ASSESSMENT REPORT

Bengalla Continuation Project – Changes to the Main Overburden Emplacement Area (SSD 5170 MOD 2)

Figure 2: Project Layout and Proposed Modified Components

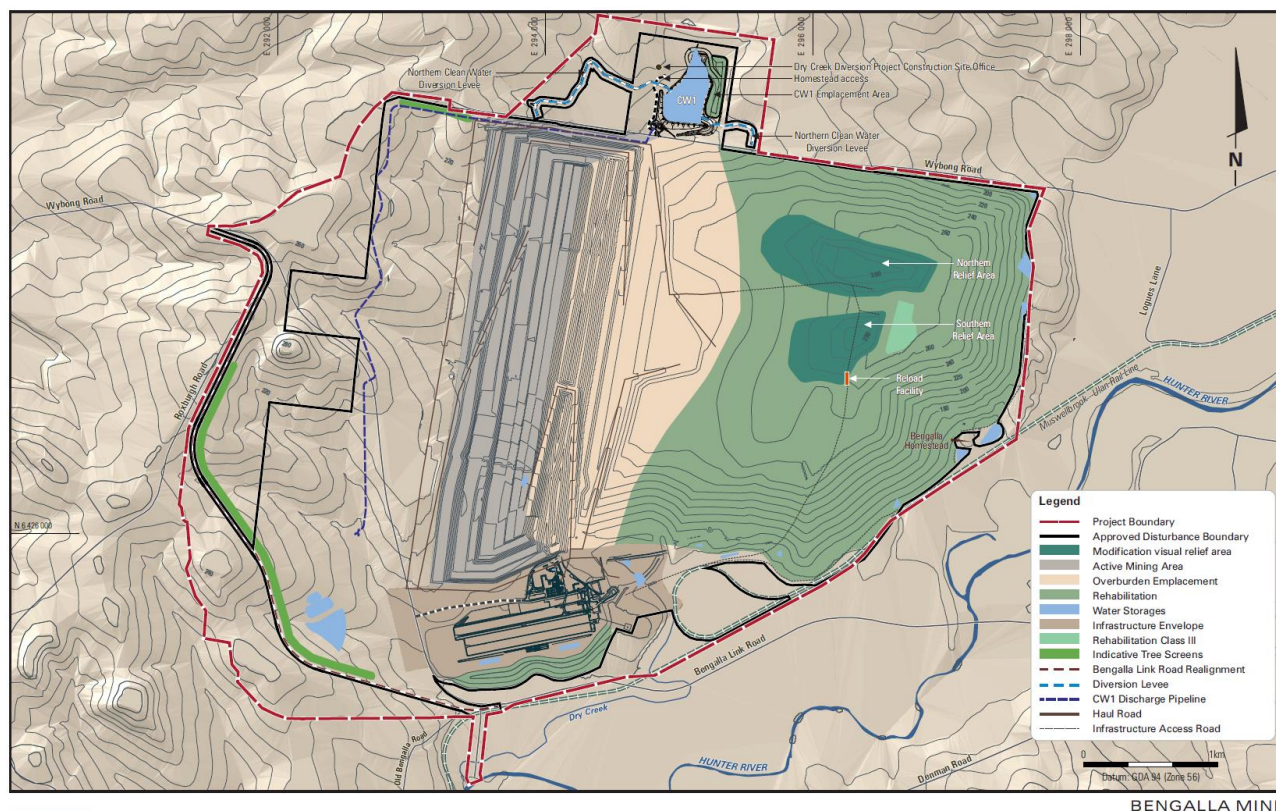
The Main OEA is located east of the mining area, approximately 3.5 km from the centre of Muswellbrook. BMC currently has approval to construct the Main OEA to a height of 270 metres reduced level (m RL). The proposal involve adding two Visual Relief Areas on top of the Main OEA (see **Figure 2**). The Visual Relief Areas are macro topographic highs (or knolls) that mimic the surrounding natural undulating landscape, as follows:

- 30 m Northern Relief Area, constructed to a maximum height of 300 m RL; and
- 20 m Southern Relief Area, constructed to a maximum height of 290 m RL.

The Department is satisfied that BMC has adequately considered the existing physical environment and economic constraints when re-designing the Main OEA. The Department is also satisfied that the proposed conceptual final landform is a better outcome than the currently approved landform.

Figure 3: Visual Assessment Locations

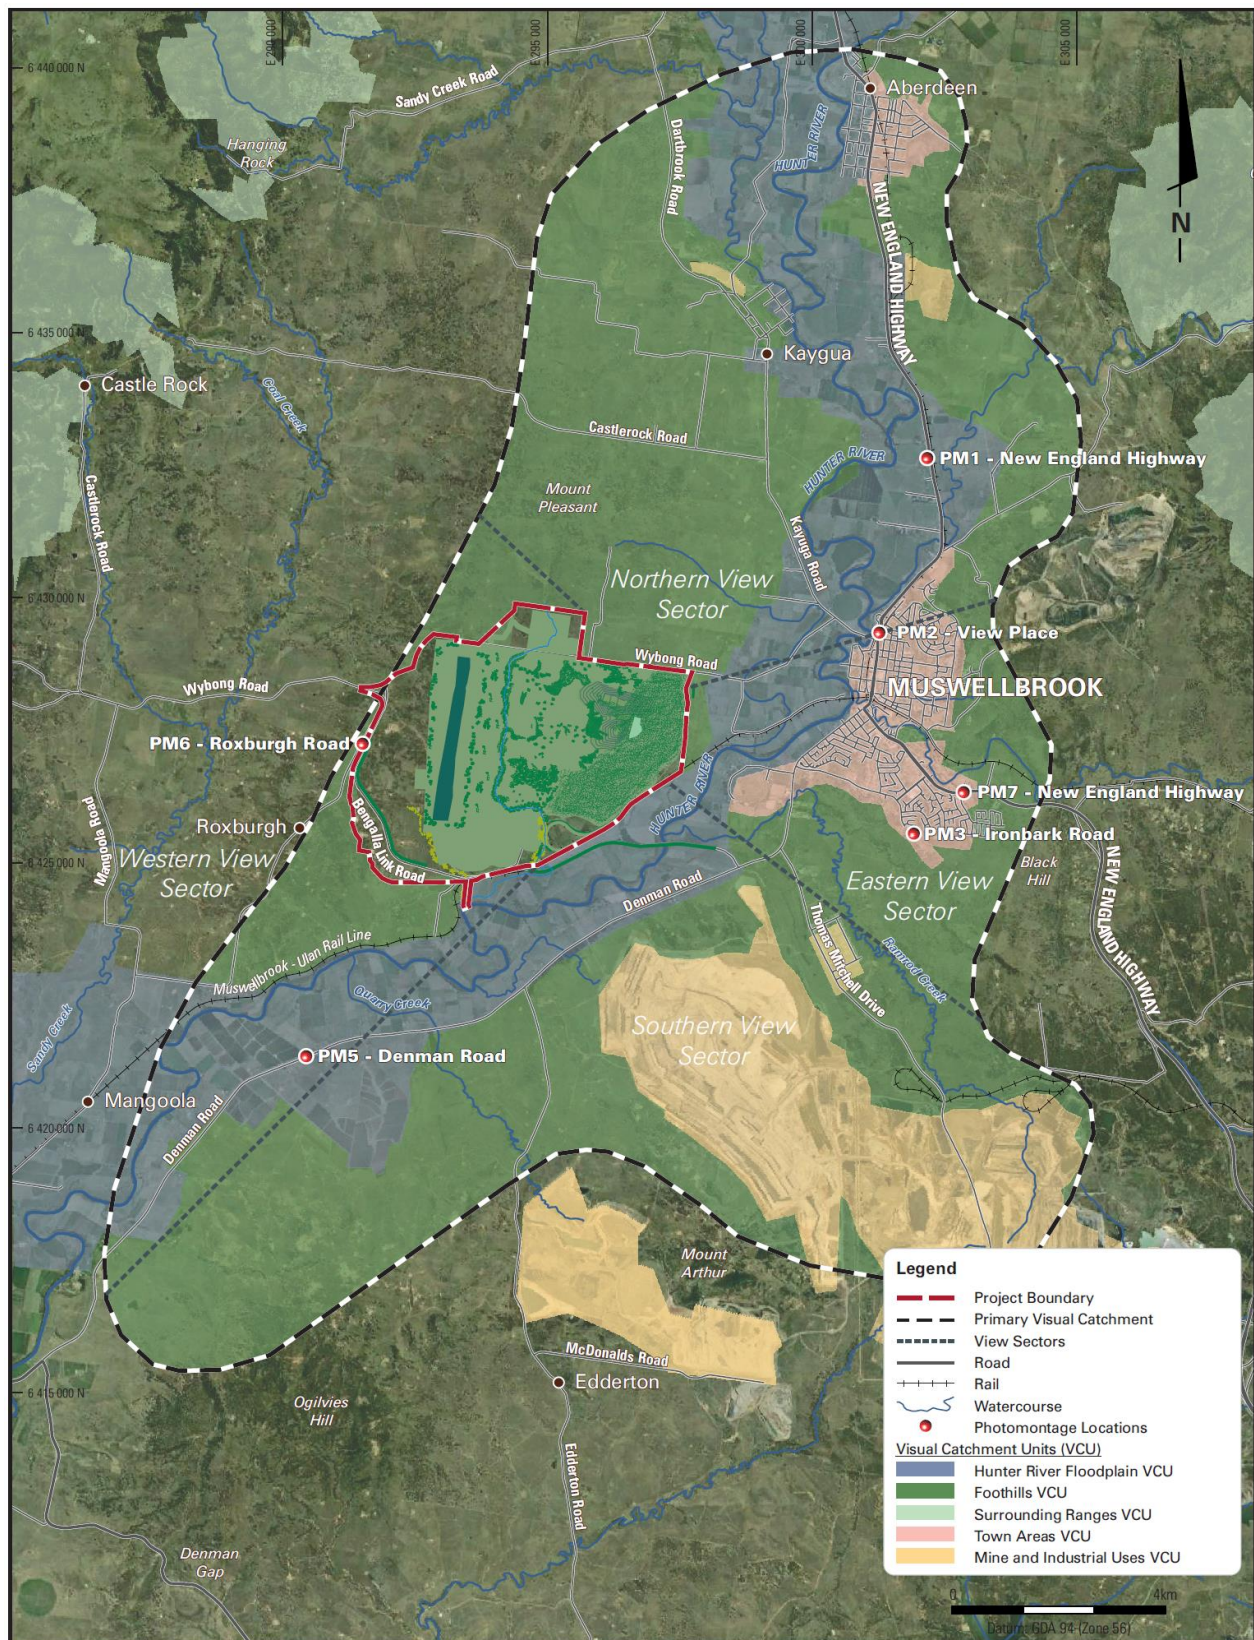
The SEE included a landscape and visual assessment, undertaken by VPA Visual Planning and Assessment. This assessment included a comparison of six representative viewpoints from four view sectors to determine the likely scale and significance of the proposed changes to the Main OEA (see **Figure 3** below).

The assessment identified that the visual impacts on the eastern view sector would be generally low to moderate due to the close proximity of sensitive residential receivers in and around the township of Muswellbrook. Impacts on the southern view sector would be low due to the lower visual sensitivity of the area from more rural land uses along Denman Road and the Hunter River Floodplain. Impacts on the northern and western view sectors would be minimal due to longer viewing distances, intermittent screening associated with existing topography and vegetation, and lower density of development in the foothill areas. The assessment concluded that, despite remaining a dominant feature in the skyline, the modified Main OEA would improve the overall visual integration of the mine with the surrounding landscape.

The Department is satisfied with the conclusion drawn in the assessment that the Visual Relief Areas would generally improve the visual amenity of the Main OEA, particularly from elevated viewing locations in Muswellbrook and along Denman Road. The Department is also satisfied that BMC considered all view sectors, but appropriately focused the re-design on improving the visual amenity for the most sensitive eastern sector, which includes Muswellbrook.
